PENNSYLVANIA
NDI No. PA 01069
PENN DER No. 10-26

TREESDALE FARM DAM

**PHASE I INSPECTION REPORT
NATIONAL DAM INSPECTION PROGRAM**

**DEPARTMENT OF THE ARMY
BALTIMORE DISTRICT, CORPS OF ENGINEERS
BALTIMORE, MARYLAND 21203**

K	RONALD E KELLEY	PROPOSED EMBANKMENT REINFORCEMENT AND DETAILS	
	TREESDALE FARMS, INC. APPLE ORCHARDS MAPS PENNSYLVANIA 16046	NO	79-117-E2 C

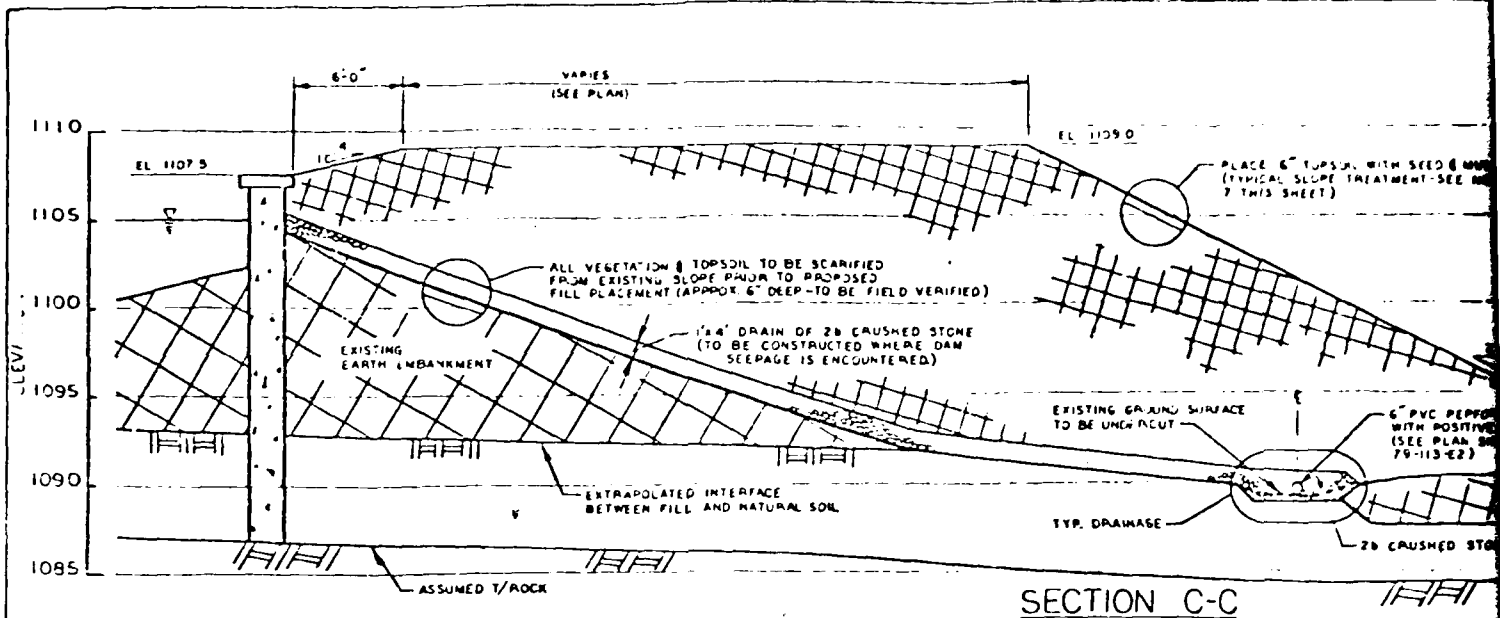
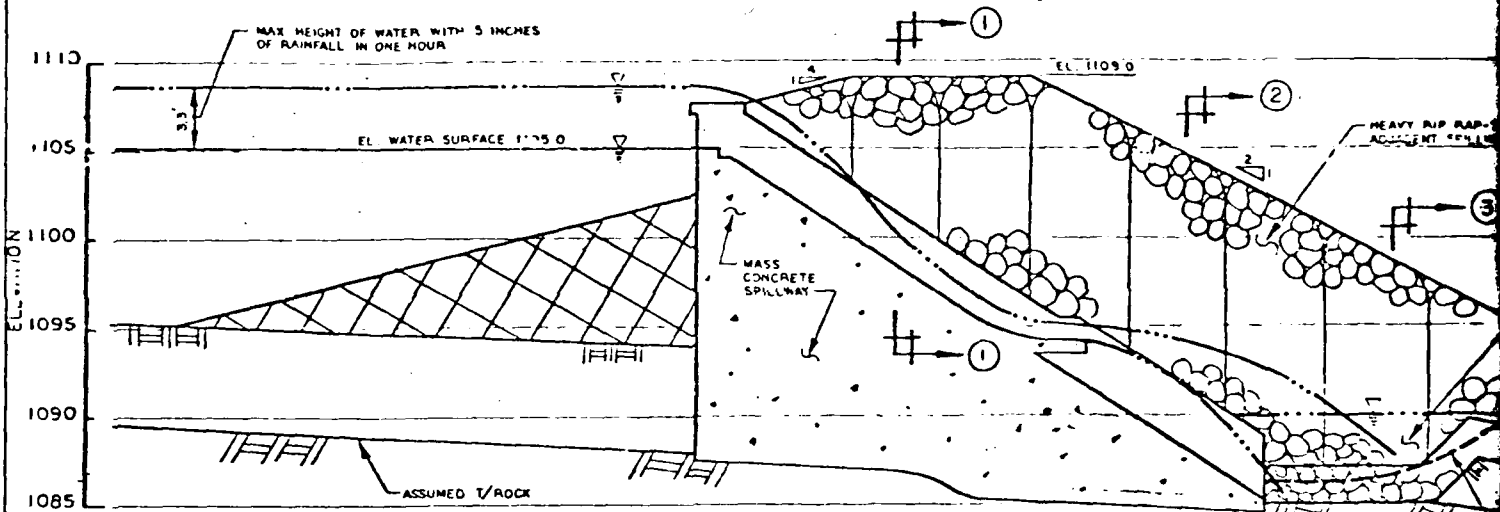
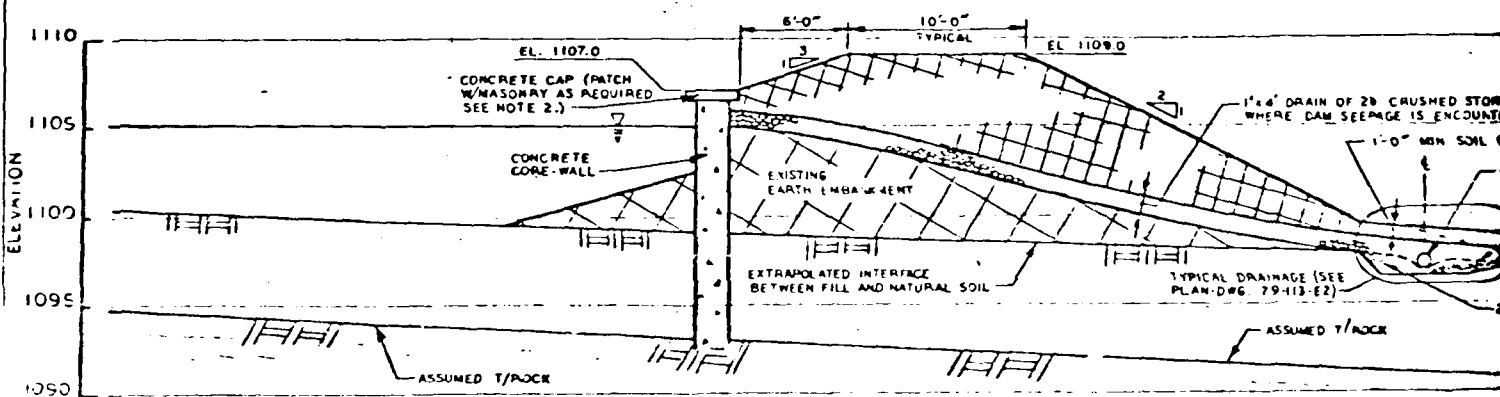
1. Surficial: Embankment modifications were in progress at the time the field reconnaissance was made. Fill, consisting of predominately clay soil, had been placed on the downstream slope in order to increase the crest elevation along a section of embankment and to improve embankment stability. Due to construction not being completed, the downstream slope was unvegetated. Mr. Norman Datt of Treesdale Farms has stated that these areas will be seeded during Spring, 1981. The upstream slope was submerged and hence could not be observed. The concrete cap of the core wall was recently reconstructed and the exposed portion of the core wall appeared in excellent condition. The crest of the fill on the downstream slope left of the principal spillway varies from El. 1101.8 to El. 1102.5 rather than El. 1103.5 as proposed.

The crest of the fill on the downstream slope left of the principal spillway varies from El. 1101.8 to El. 1102.5 rather than El. 1103.5 as proposed (Plate No. 8). Until construction is completed, the dam will have less freeboard than planned. This may or may not be a deficiency, depending upon the results of the hydrologic/hydraulic analysis.

1. Complete the repairs and modifications to the dam and develop a dense grass cover on the downstream slope of the embankment and auxiliary spillway.
2. Remove the fill (temporary access road) obstructing the downstream channel.
